NEC Microcomputer Technical Information

<p style="text-align: center;">μPD789800 Subseries</p> <p style="text-align: center;">Document Modification</p>		Document No.	SBG-DT-0032-E	1/1
		Date issued	November 7, 2001	
		Issued by	Microcomputer Group Sales Engineering Div. NEC Electron Devices NEC Corporation	
Related documents	User's manual: U12978EJ2V0UM00 Data sheet: U12627EJ3V0DS00 Data sheet: U12626EJ2V0DS00	Notification classification		Usage restriction
				Upgrade
			√	Document modification
				Other notification

List of Corrections to Documents in μ PD789800 Subseries

Figure 8-31. Flow Chart of Remote Wake-Up Control Operation

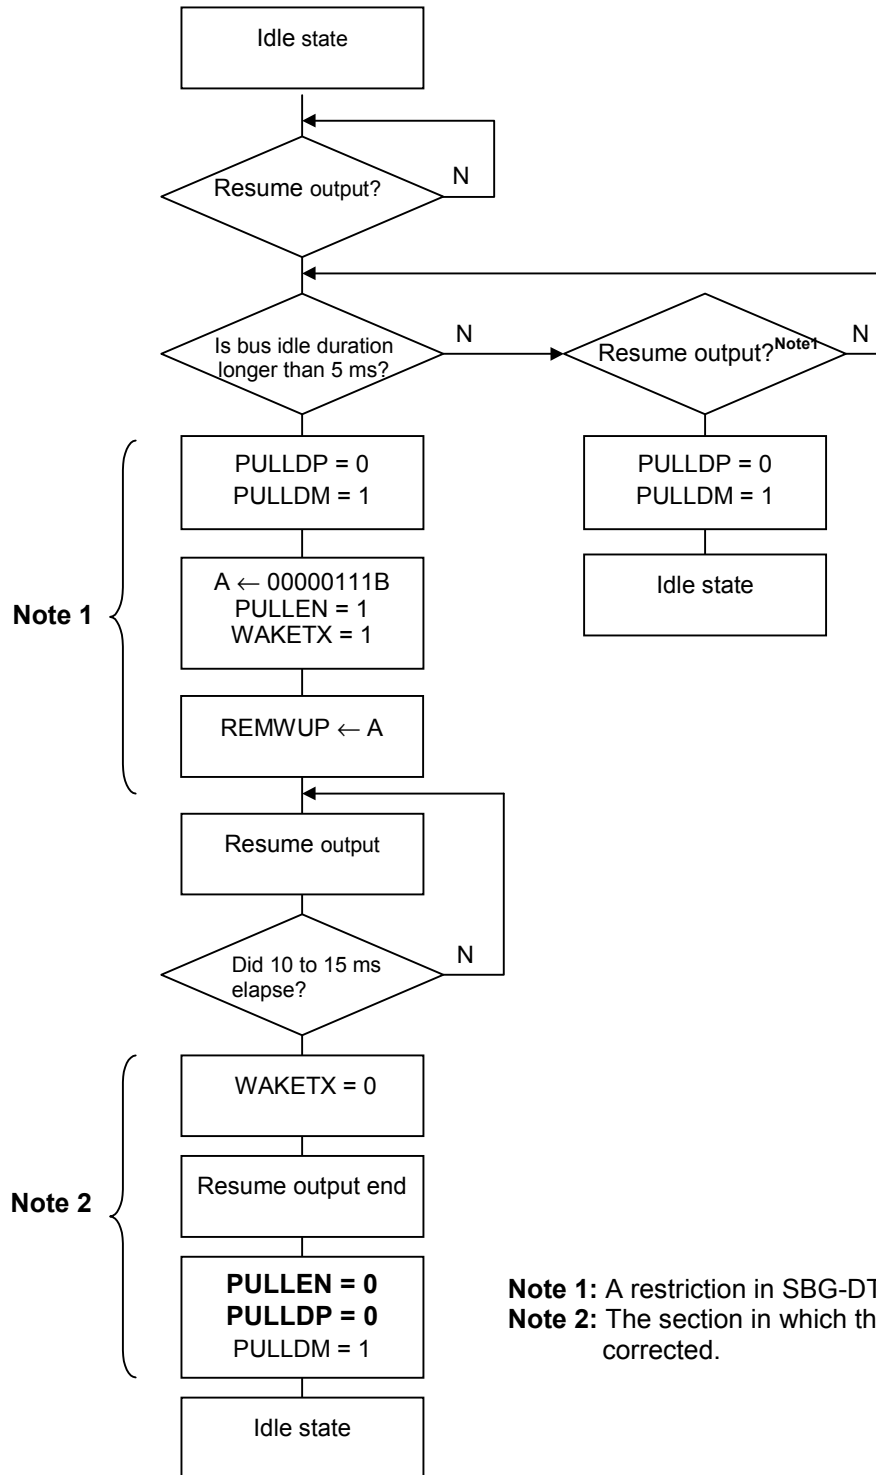
The software to output the Resume signal described on pages 145 and 146 in the user's manual cannot conform to USB specification Rev1.1. An example of the correct software is shown below.

Incorrect) (Description in the present user's manual)

2. Be sure to follow the exact instruction sequence to append EOP when terminating Resume output.

CLR1 REMWUP.2      ; (PULLDP ← 0) , EOP generation
NOP                ; Be sure to input
SET1 REMWUP.3      ; (PULLDM ← 1) , "J" state generation
CLR1 REMWUP.0      ; (WAKETX ← 0) , Resume output end
CLR1 REMWUP.1      ; (PULLEN ← 0)

The location of this correction is in Figure 8-31 Flow Chart of Remote Wake-Up Control Operation on page 145, which is shown below.

Correct)

2. The instruction sequence when terminating Resume output is as follows.

CLR1 REMWUP.0      ; (WAKETX ← 0), Resume output end
CLR1 REMWUP.1      ; (PULLEN ← 0),
CLR1 REMWUP.2      ; (PULLDP ← 0) }      "J" state generation
SET1 REMWUP.3      ; (PULLDM ← 1) }
